# **APPENDIX F: Development Review Reports**

## **Neighborhood Meeting Report Boynton Yards, 99 South Street**

## Boynton Yards – Building 3

### **99 South Street/BY Building 3**

**Preferred Massing Option**  
**Option C: Zipper**

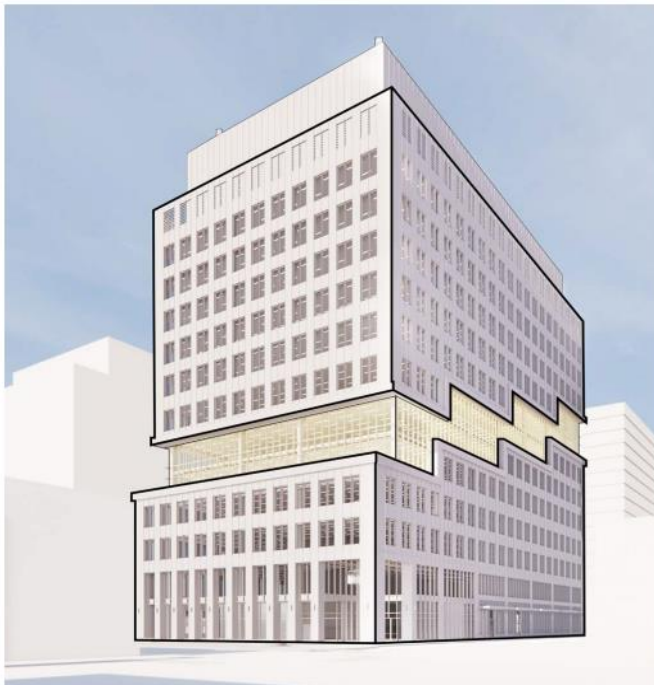
- **Comment:** Building façade design selection.
  - **Response:** The Commission voted on the 3-step option as the preferred zipper option and "Option b" for north façade. The project design is consistent with design guidelines for high rise buildings. The Proponent will consider accommodating mirrored condition on zipper between north and south façade with the use of windows and frames.

- Additional work needed to accommodate a mirrored condition at the zipper between the south and north façade with the windows and frame.

The Commission voted unanimously (4-0) to recommend approving façade option C, voted unanimously (4-0) to recommend approving massing option 3 (Zipper), voted unanimously (3-0) that all of the HR design guidelines were satisfied, and voted unanimously (3-0) to incorporate further design guidance into the final design for the building.
